ADDENDUM #1

Date: October 20, 2017

**KENWORTH SALES COMPANY, INC.
ONTARIO, OREGON
NEW BUILDING ADDITION**

AD1.0

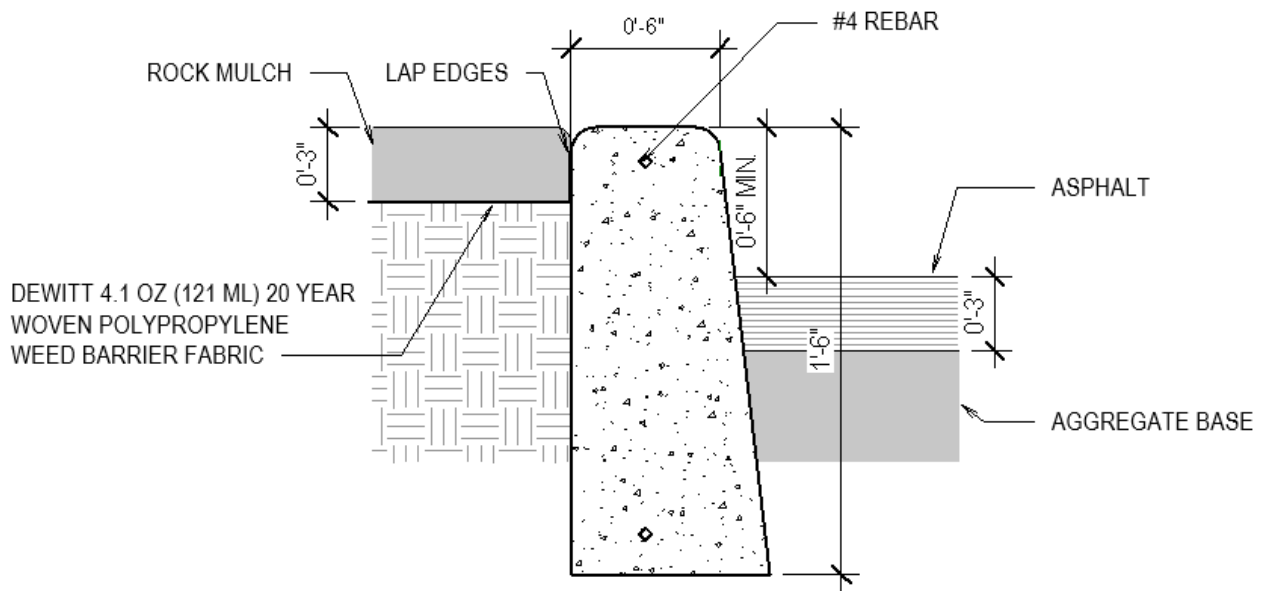
1. Sheets SD1.1 and A1.1 - the fire hydrant location is incorrectly shown on these sheets - see sheet C1 for correct fire hydrant location.
2. Sheet A1.1 - see attached AD1.0 for revised location of door 102C.
3. Sheet A5.1 Detail 11 - replaced by attached AD1.1. See also C4 Detail 11.

SHEET TITLE:
Door 102C Revised Location

M1.1
Revised-1

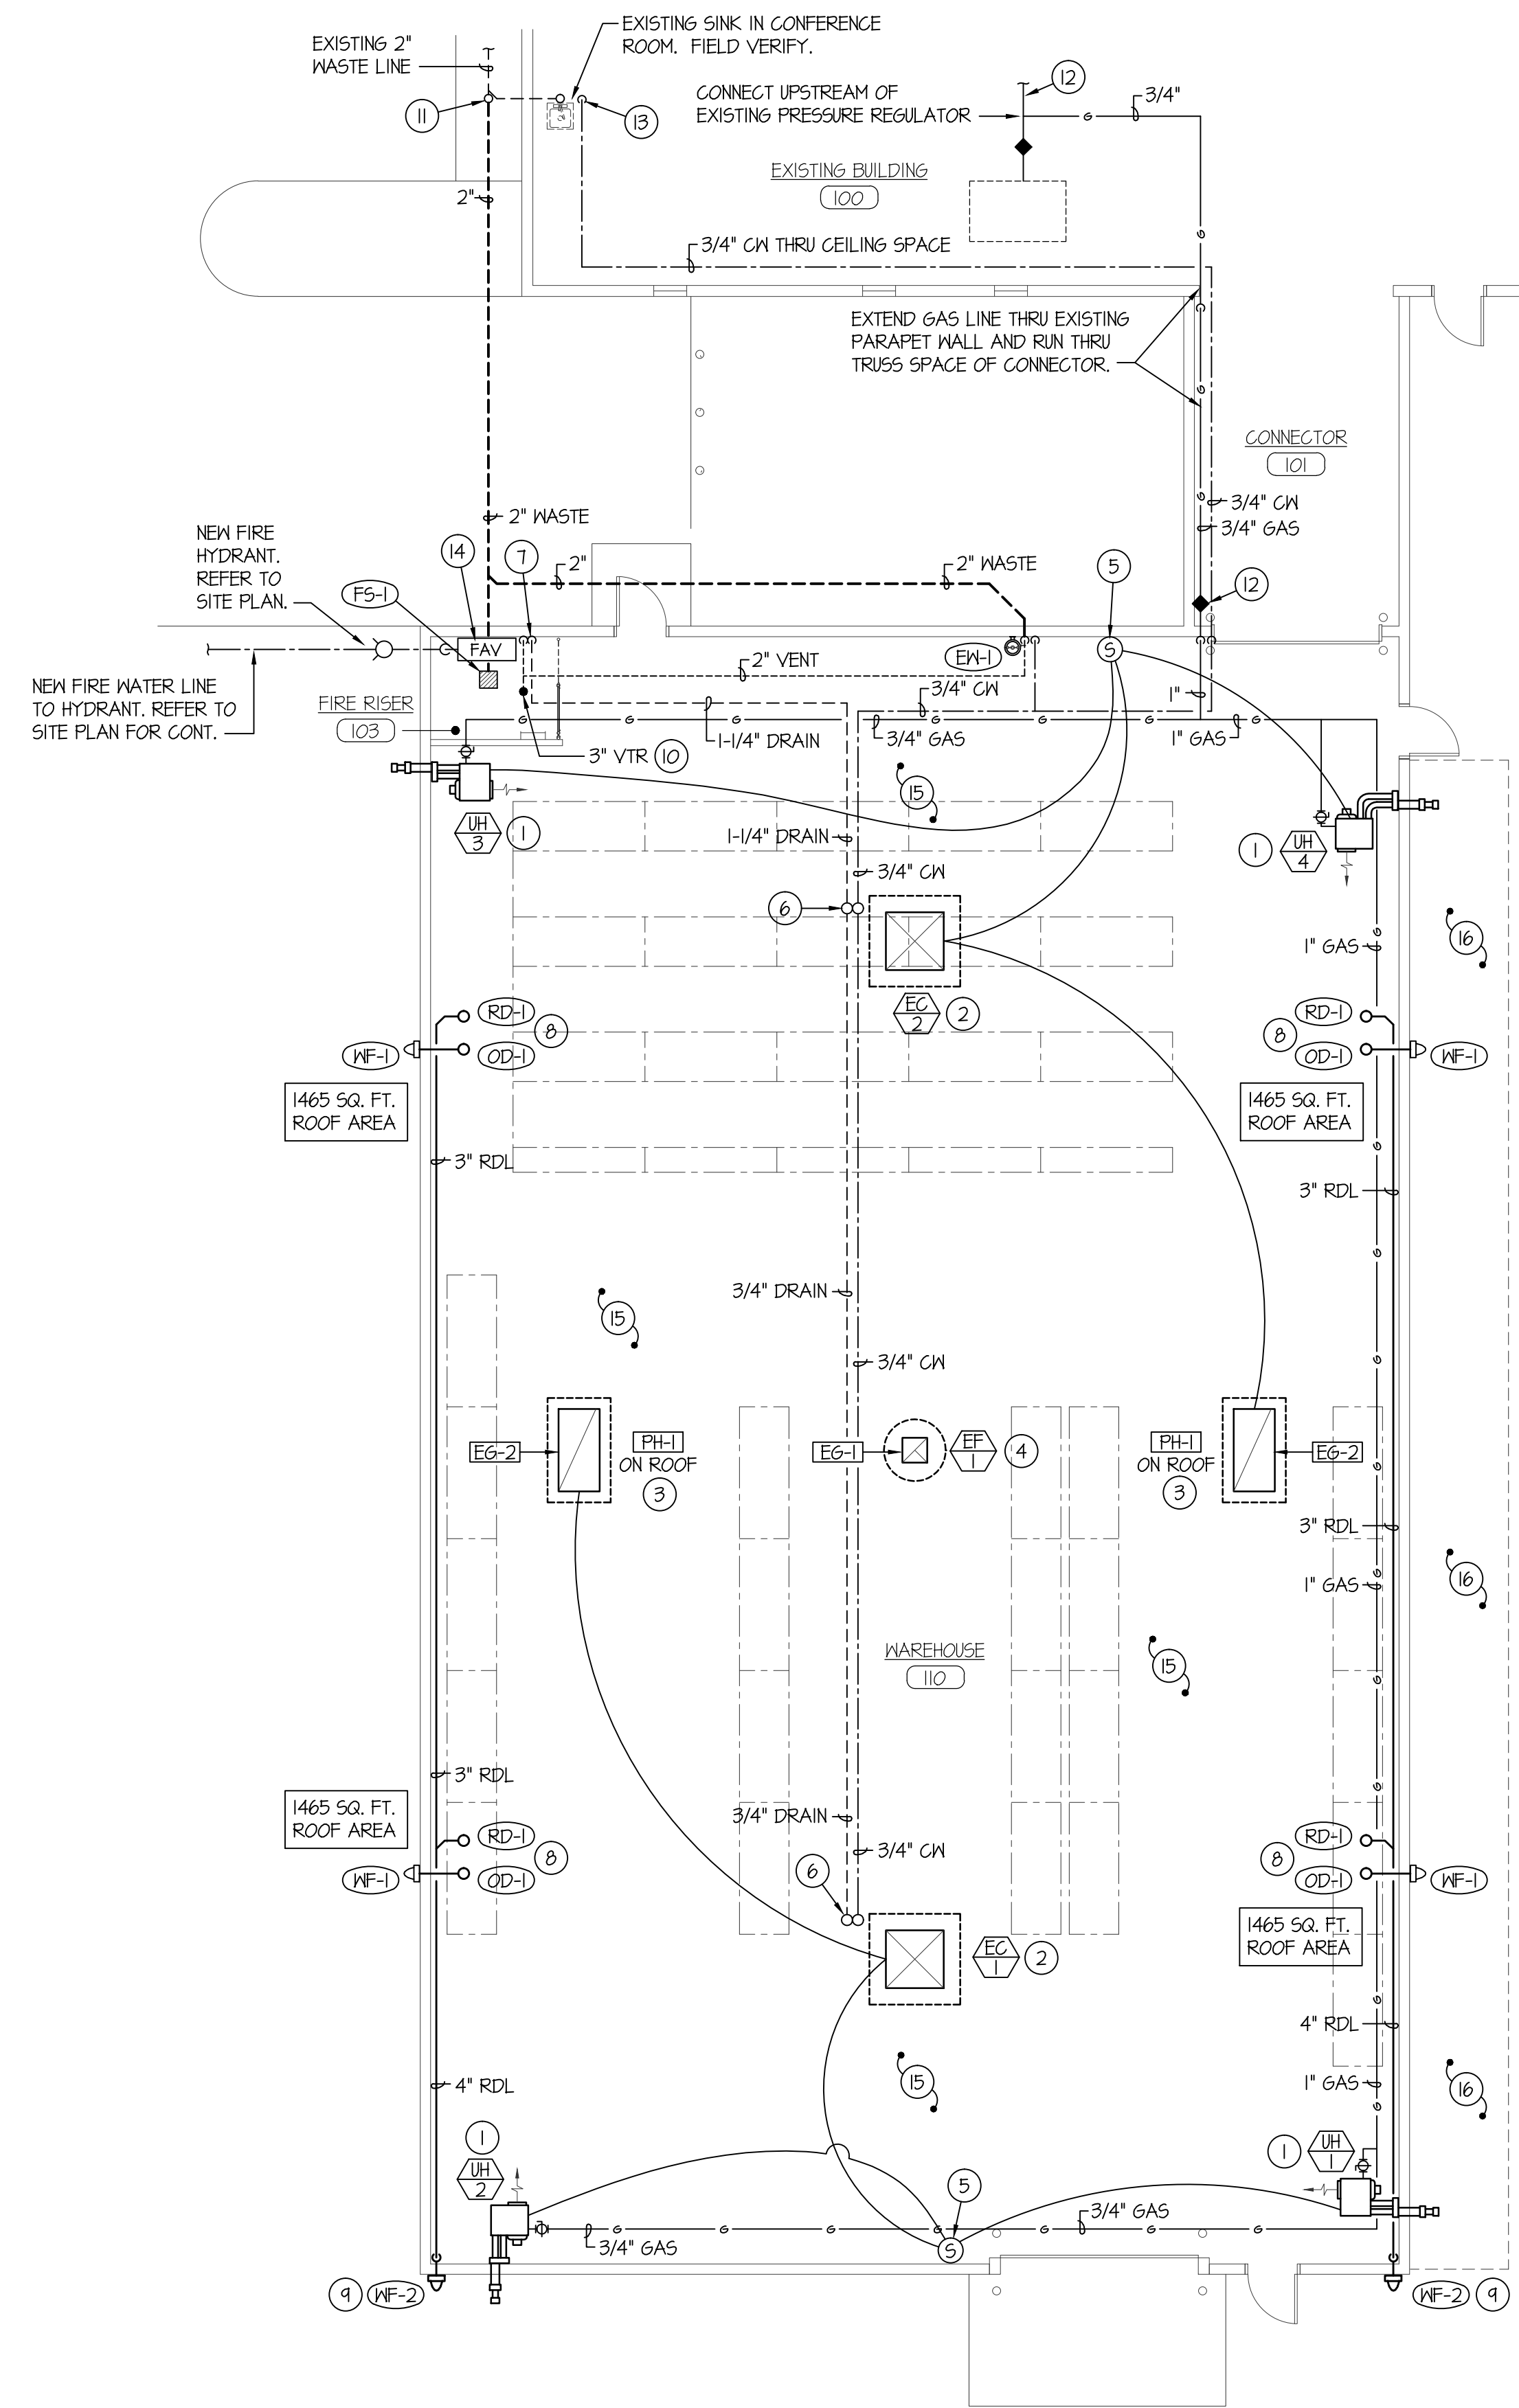
1. Connect the 3/4" cold water line to the existing 1/2" (or larger) cold water line at the ceiling near the existing sink and run in ceiling space as shown to new addition. Core drill through existing concrete block walls as required to run new line. Remove and replace ceiling materials as required to install new water line.

1. Sheet M1.1 has been replaced - see attached.

- CONNECT 3/4" COLD WATER LINE TO EXISTING 1/2" (OR LARGER) COLD WATER LINE NEAR EXISTING SINK. RISE WATER LINE UP AND RUN IN CEILING SPACE AS SHOWN TO NEW ADDITION.
